# Traffic Impact Assessment

5-13, 15 & 17 Maxwell Drive, Bridgewater  
TAS 7030

August 2022

The Council RFI letter dated 15/06/2022 (ref: DA2022/134) has mentioned several traffic/parking related matters. These matters are extracted below, with responses to each of them provided.

Figure 9: Proposed signage and speed bump plan

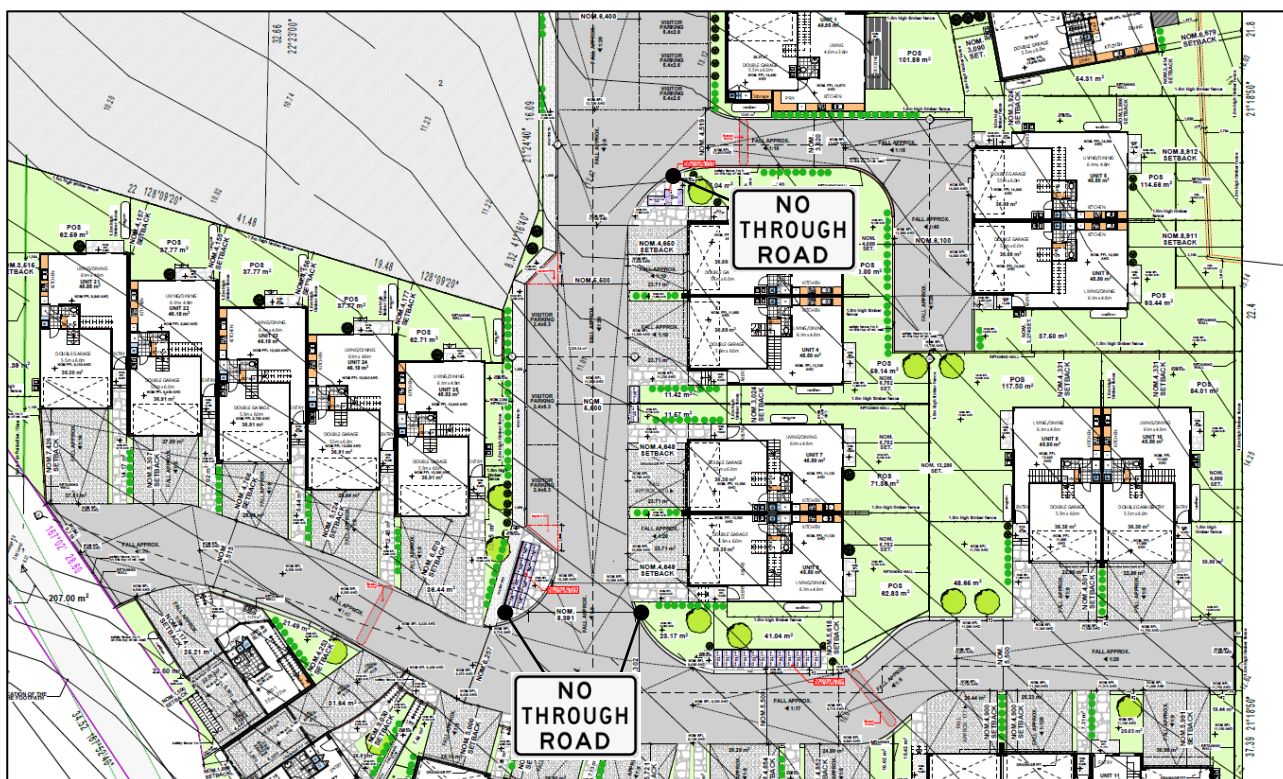
Please provide an amended proposal plan and TIA addressing vehicle turning at the end of the shared driveways. Advice: no dedicated turning areas have been provided at the end of the shared driveways. A vehicle is unable to turn if the private driveways/parking spaces are occupied.

The proposed arrangement will prevent any vehicles other than the resident vehicles from accessing the dead-end road sections through the provision of speed bumps and 'No through road' signs at the entrance to the side roads from the main accessway – refer to **Figure 9**. The proposed visitor car spaces will be clearly demarcated with signage so that visitors are aware of where to park their vehicles, without needing to access the dead-end road sections. The above measures are considered suitable and sufficient alternatives to providing dedicated turning areas at the ends of dead-end roads.

Figure 10: Existing driveways on the southern side of Maxwell Drive

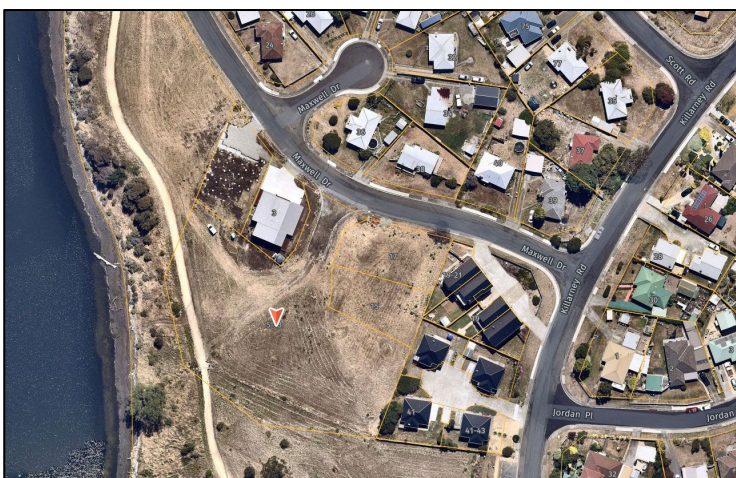
Please demonstrate that the proposal can satisfy performance criteria P1 of Clause C.2.6.3. This response should have regard to pedestrian amenity/ safety.

Maxwell Drive is a local road that only serves vehicles accessing the residences between Killarney Road and Scott Road. As a result, there are currently limited levels of traffic on this road. The proposal will construct a main driveway and two other separate driveways for Dwellings 1 and 2, off Maxwell Drive. There are currently 3 other driveways on the southern side of Maxwell Drive (see **Figure 10**). With the proposal, there will be a total of 6

Figure 12: Proposed safety barrier

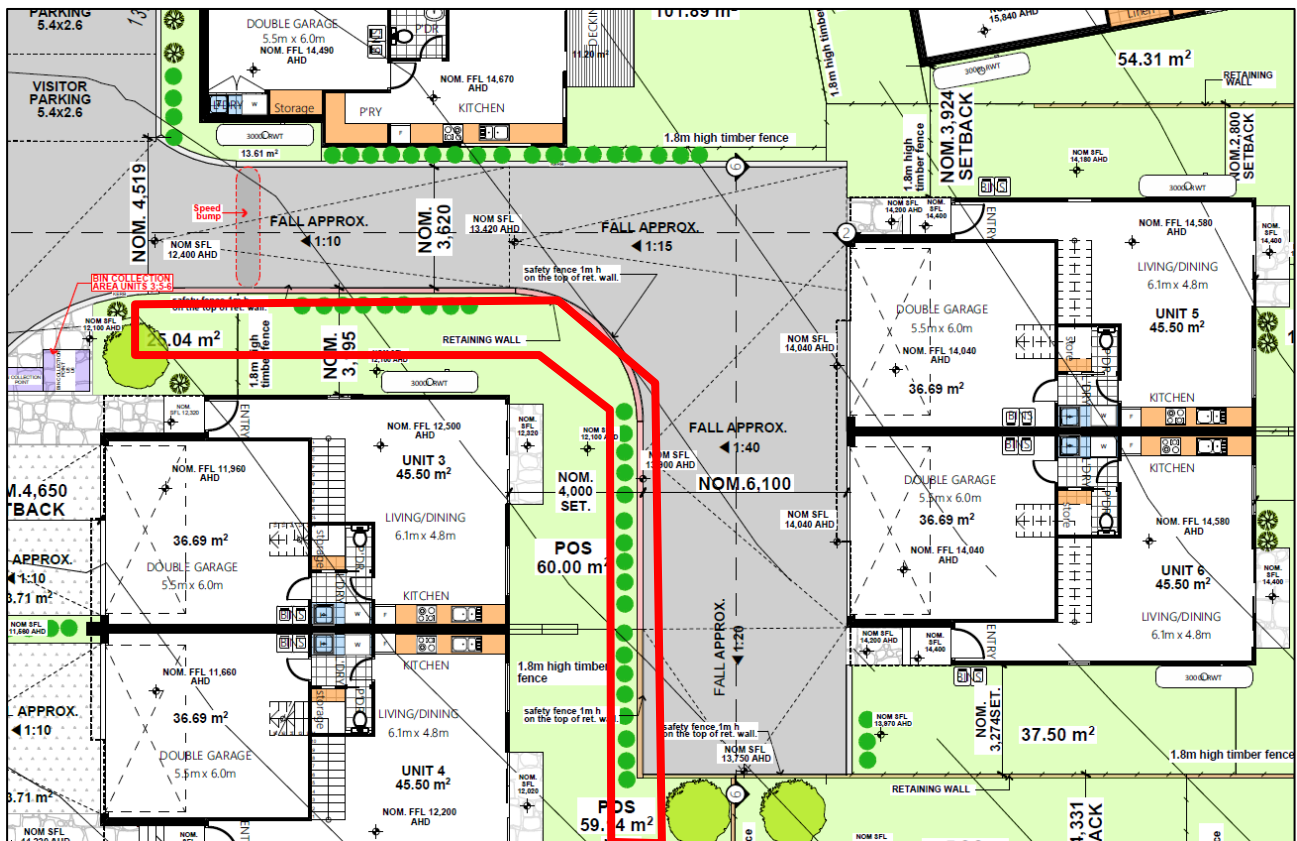
Barriers required where the driveway has a vertical drop e.g., between units 22 and 23

A 1m high safety fence (on top of the retaining wall) is proposed along the southern side of the driveway towards Dwellings 5 and 6, as shown in **Figure 12**.
